SB-008

Service Bulletin

Potential of untapped screw holes for video head mounting.

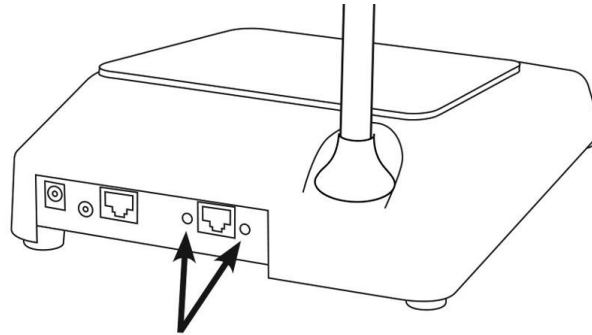
A limited quantity of 1500 counter stations do not have threaded holes for mounting a 1501/1502L video head.

Two holes on the rear of the counter station should have tapped threads for mounting the video head option. The affected units have holes that are not tapped.

Only use approved self-tapping screws: AAC Part # 711-438 (#6 x 1/2" Type A self-tapping Phillips / pan head screws) to mount the optional video head. We recommend installing these by hand with a screwdriver, instead of using a power-driver to avoid stripping the holes.
